Date: Sun, 05 Oct 2003 17:29:20 +0000
To: ve7bqh@shaw.ca, kl6m@arrl.net
From: Peter Sundberg <sm2cew@telia.com>
Subject: 2 mtr quad

Info on my quad.

Subject: Re: 144 quad feed

Electrical data

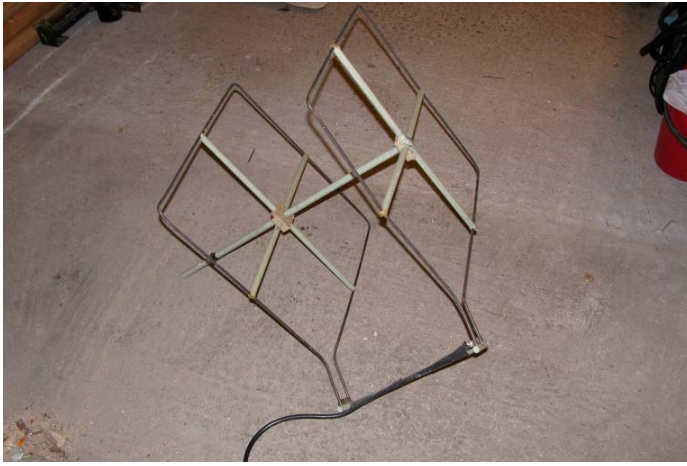
<u>Fq</u>	<u>R</u>	<u>X</u>	<u>Returnloss</u>
143.800	59	0	
144.000	56	0	24 db
144.200	53	0	
144.400	51	1	38 db
144.600	49	3	31 db
144.800	47	5	25 db
145.000	45	7

Bandwidth vswr 1.5:1 from 142.6 -> 146.5, wider than I thought!
